## CALIFORNIA COASTAL COMMISSION

**A-3-MRA-19-0034 / 9-19-0918**

### EXHIBITS

SUBJECT: CalAm Monterey Peninsula Water Supply Project

### Groundwater Elevation in MPWSP MW-7

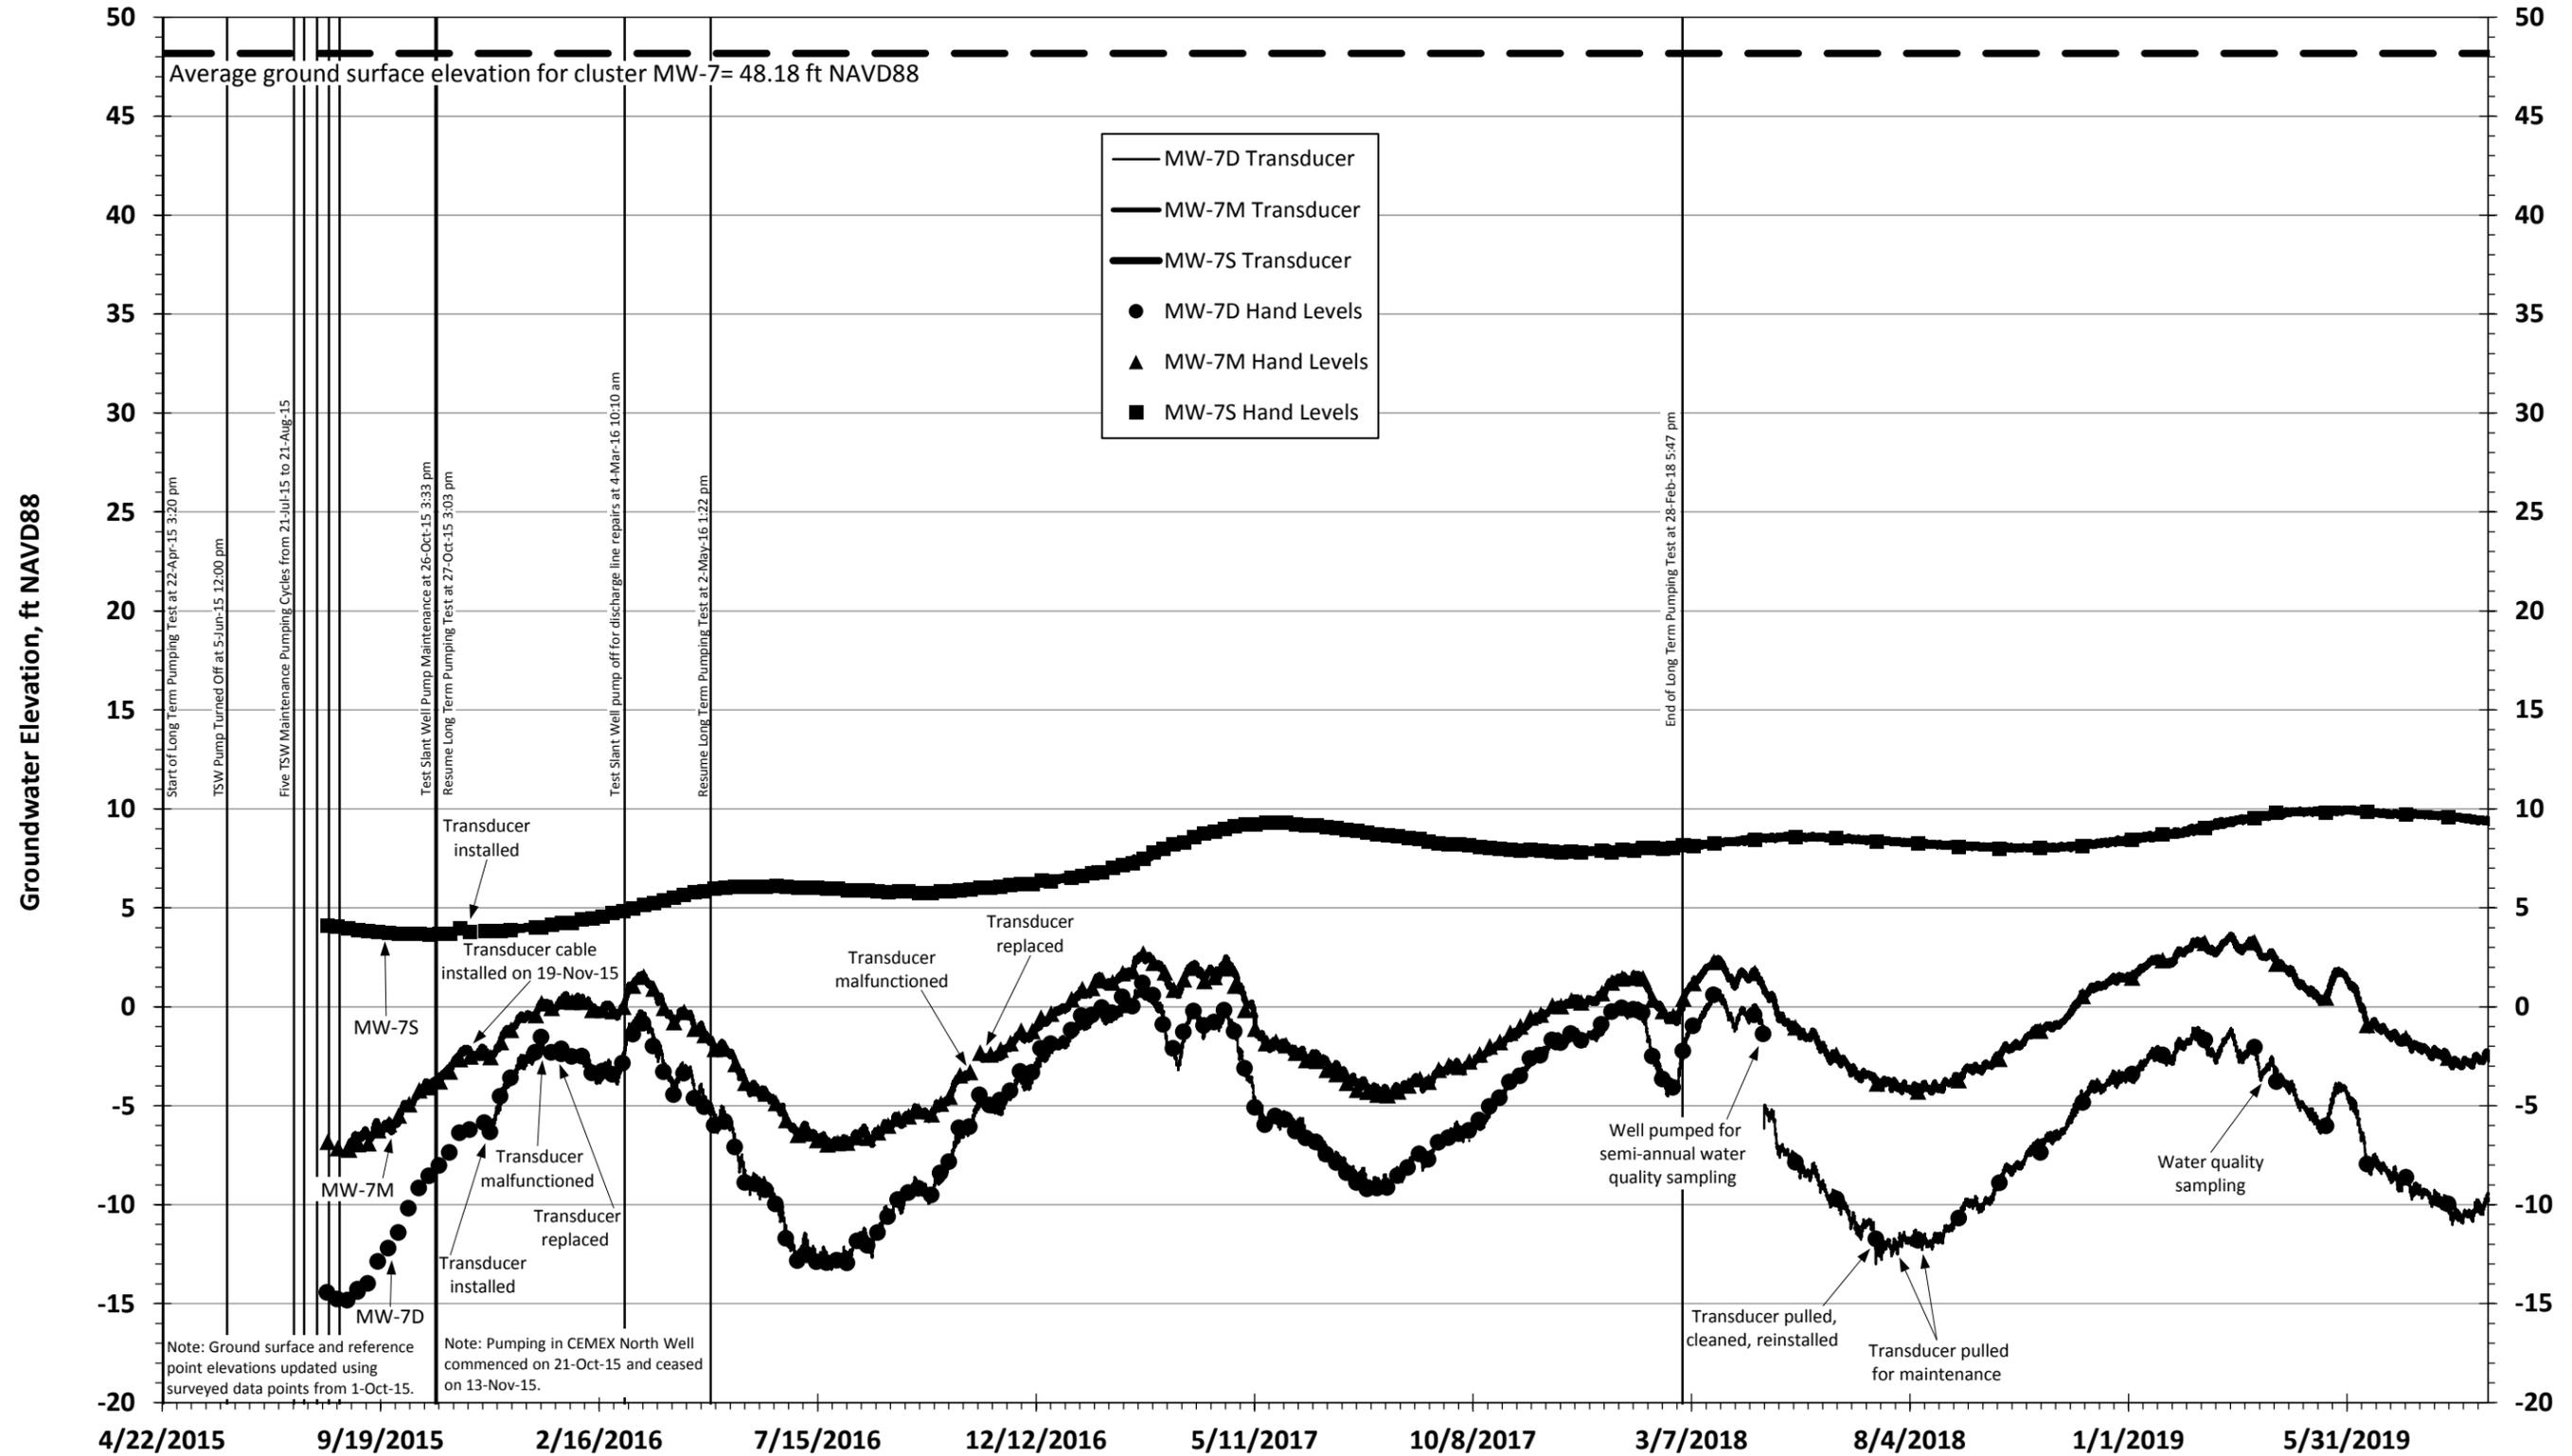
Further evidence of hydraulic separation between the Dune Sand and 180-Foot Aquifers at the MW-7 comes from water level trends at MW-7S relative to MW-7M. MW-7S rose approximately 6 feet between October 2015 and June 2017, from approximately 4 feet NAVD88 (1-foot above mean sea level [MSL] which is at 3 feet NAVD88) to 9 feet NAVD88, presumably in response to above-average rainfall following a period of drought. During this time, the water level in MW-7M remained at or below MSL (3 feet NAVD88) (Figure 7).

Figure 10

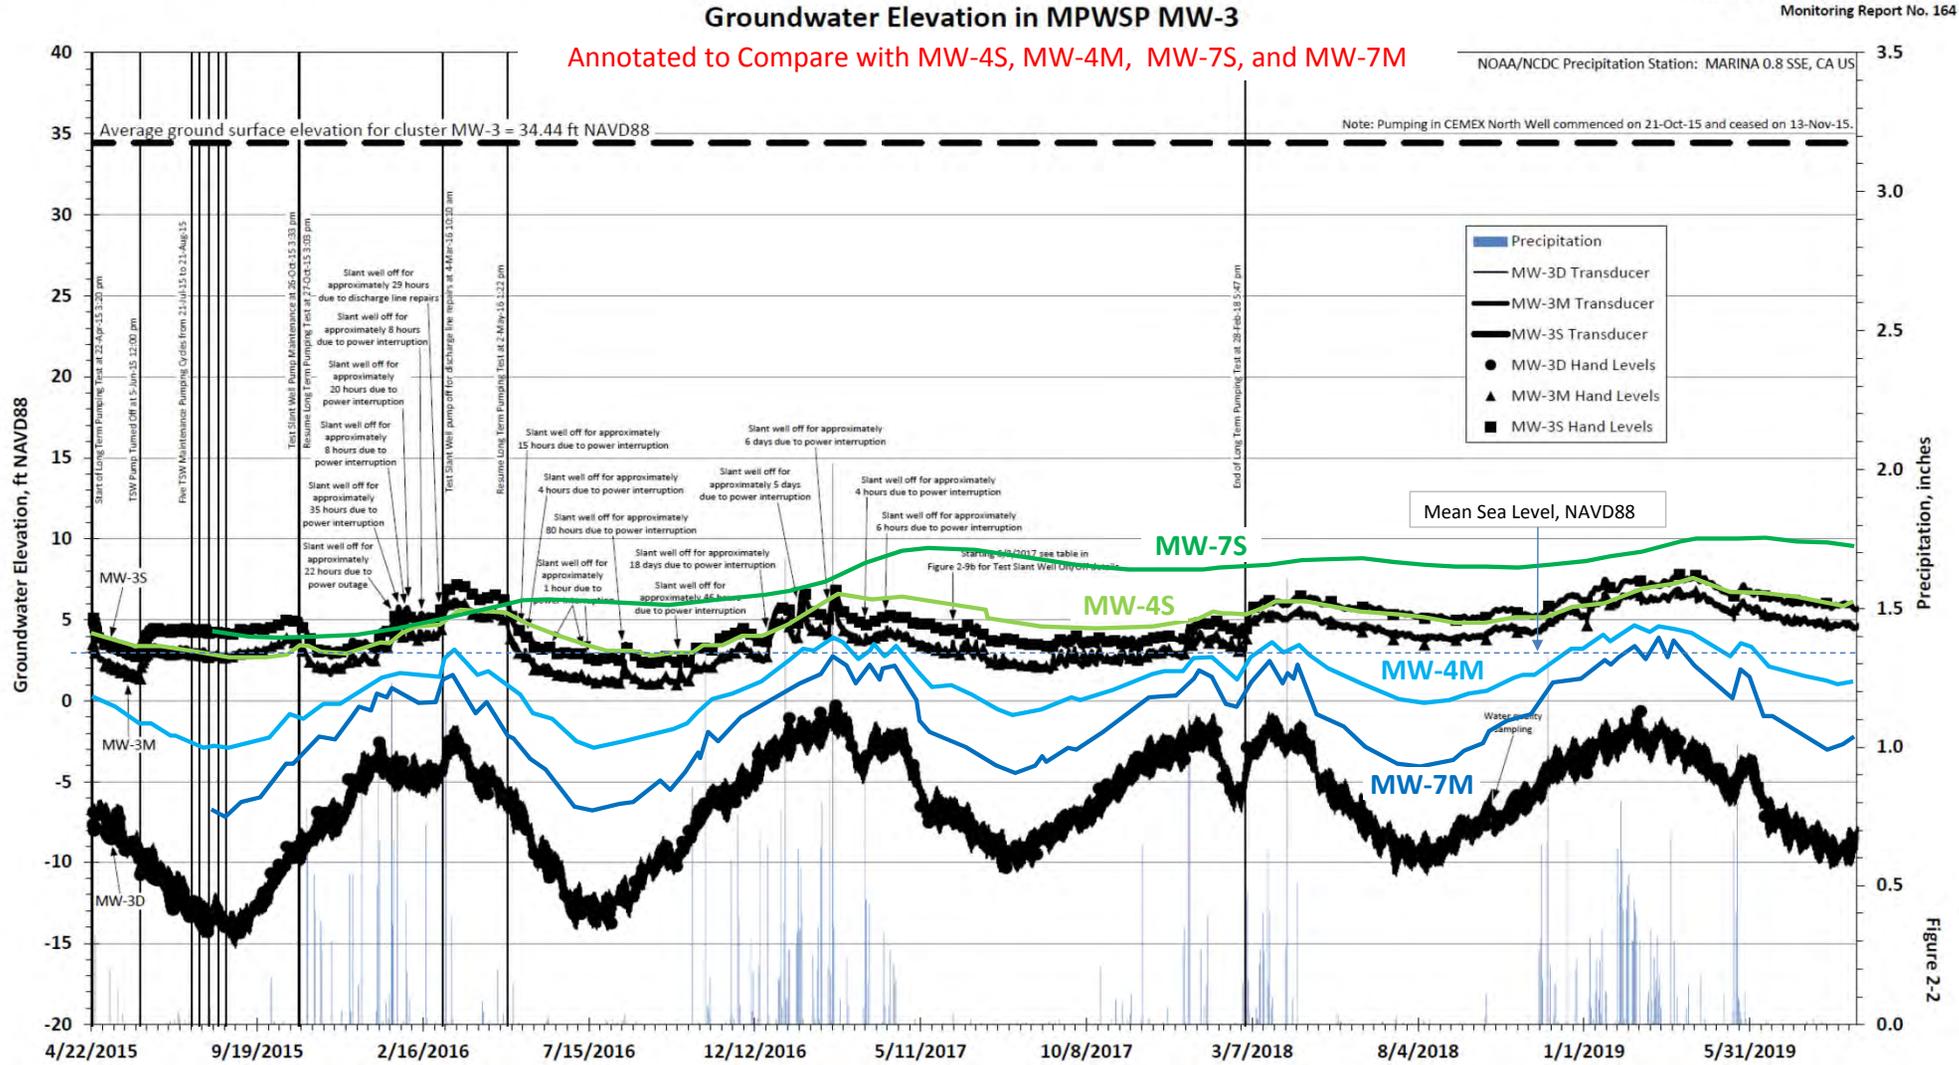
To illustrate changes in groundwater gradients over time between well clusters MW-3, MW-4, and MW-7, the hydrographs of MW-4S, MW-4M, MW-7S, and MW-7M have been overlain in shades of blue and green on the MW-3 hydrographs (Figure 10) to allow comparison of water levels between these wells. The groundwater gradient between the wells over time can be calculated by selecting two of the “S” or “M” hydrographs and dividing the difference in feet between their water levels at any point in time by the distance in feet between the two wells.

Figure 18

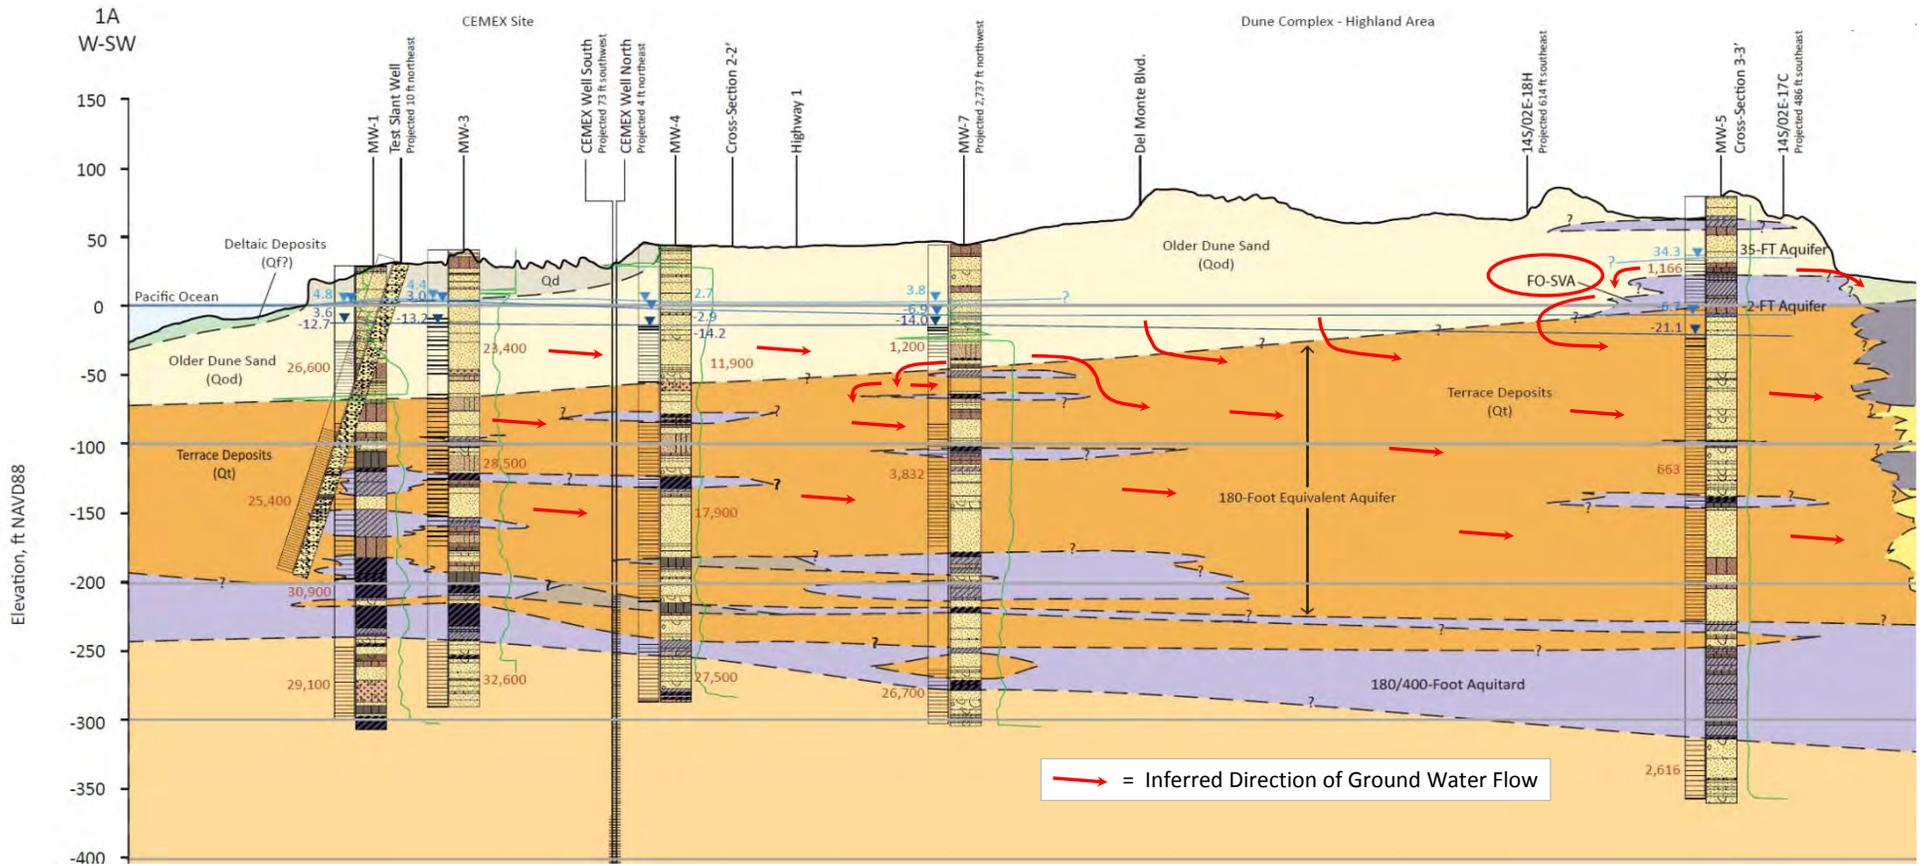
While not illustrated specifically, CSM-1 is described extensively in the Final EIS/EIR<sup>(7a, 7b, 7c, 7e, 7f, and 10)</sup> and shown on Figure 18 which was developed for this report by annotating Geologic Cross Section 1A-1A’ (Figure 12). Key features of CSM-1 are:

- The clay layer at MW-7 separating the Dune Sand Aquifer and 180-Foot Aquifer is of limited extent, such that water held up by it at a higher elevation flows laterally until it encounters the edges of the clay layer, or gaps in it, then flows vertically down into the 180-Foot Aquifer as depicted on Figure 18.

**Figure 29**

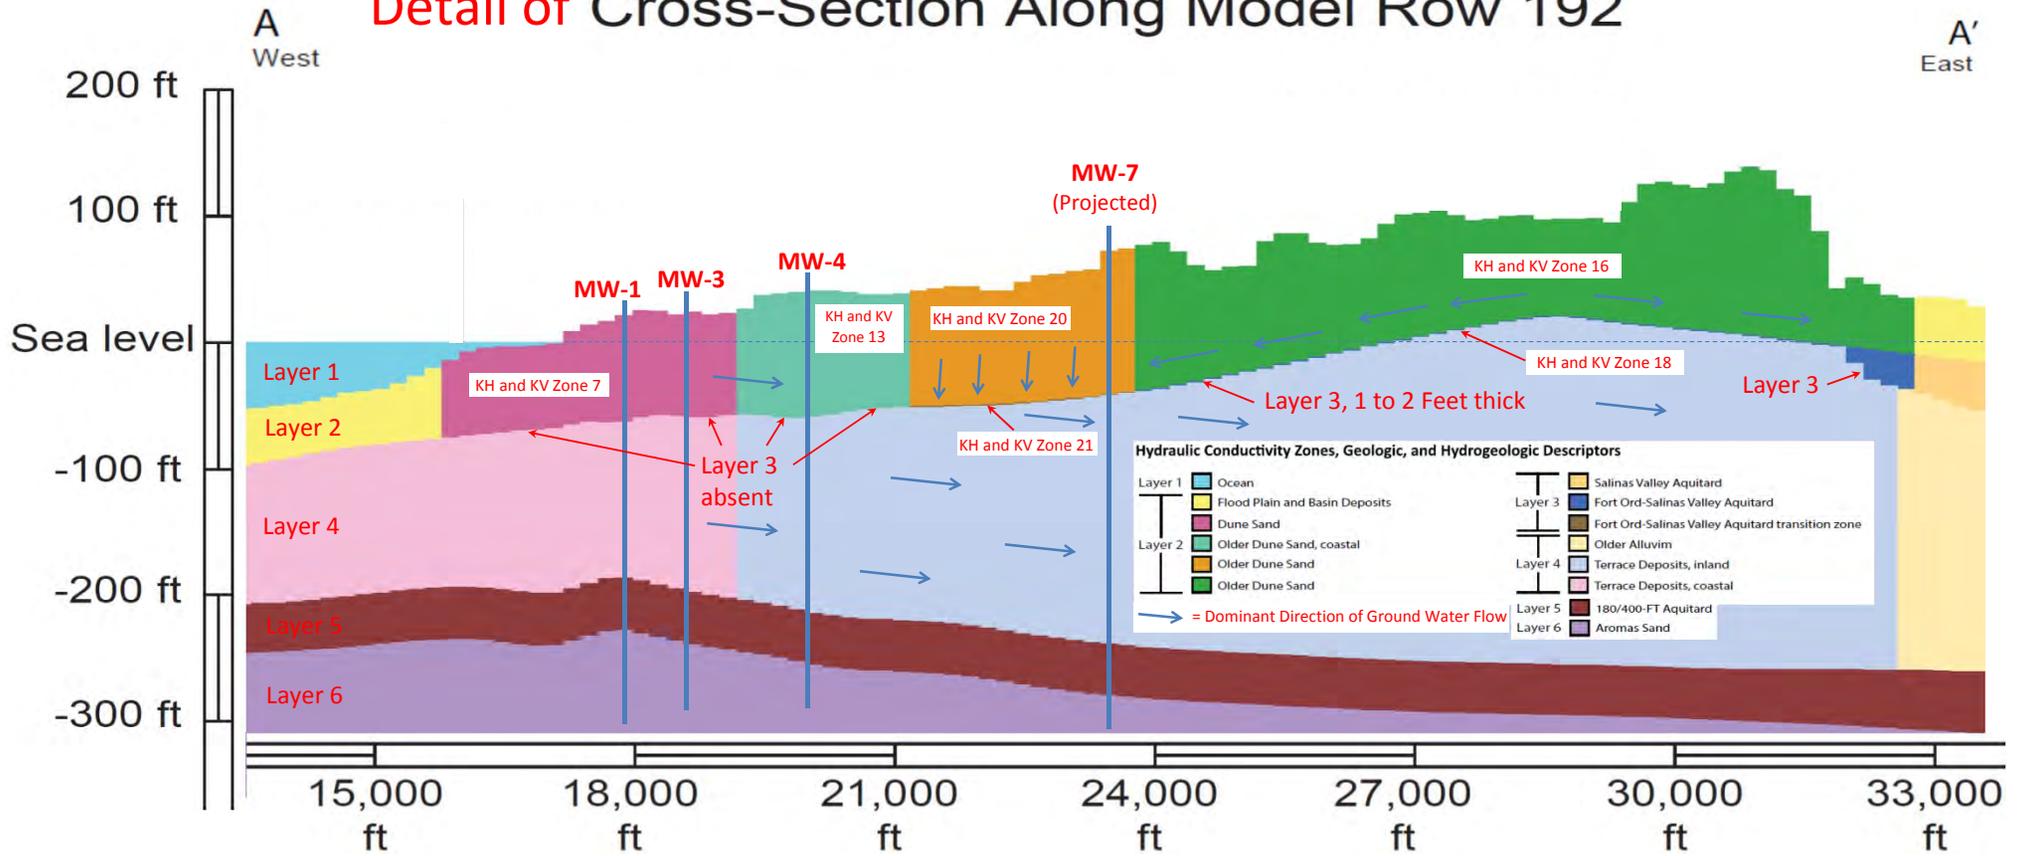
- The horizontal hydraulic conductivity (HK) assigned to the Dune Sand Aquifer inland of the well field, represented by model Layer 2, Zones 16 and 20 (Figures 27 and 29), is 2 and 4 feet per day (ft/day), respectively, which is very low for dune sand. These model values are at the bottom end of the range in values from other sources (Figure 27) of up to 250 ft/day for Zone 16 and 400 ft/day for Zone 20. Indeed, all of the surrounding Zones in Layer 2 are assigned HK values of 1 to 3 orders of magnitude higher than Zones 16 and 20.

- The vertical hydraulic conductivity (VK) assigned to the FO-SVA in Zones 18 and 21 (Figures 28 and 29) is 0.0000005 and 0.0005 ft/day. This indicates that the FO-SVA is considered essentially impermeable in Zone 18, such that groundwater flow above it in the Dune Sand Aquifer (Zone 16 of the model; Figure 29) will be predominantly horizontal. In Zone 21, which includes MW-7, the vertical groundwater gradient across the FO-SVA is on the order of 1 to 10, given modeled thickness of the FO-SVA of 1 to 2 feet at that location, in contrast to the far lower horizontal gradient within the overlying Zone 20 (Dune Sand Aquifer), measured in the range of up to 0.0012. The result of this is that movement of groundwater out of Zone 21 is approximately 2 orders of magnitude greater vertically downward than in the horizontal direction (Figure 29).
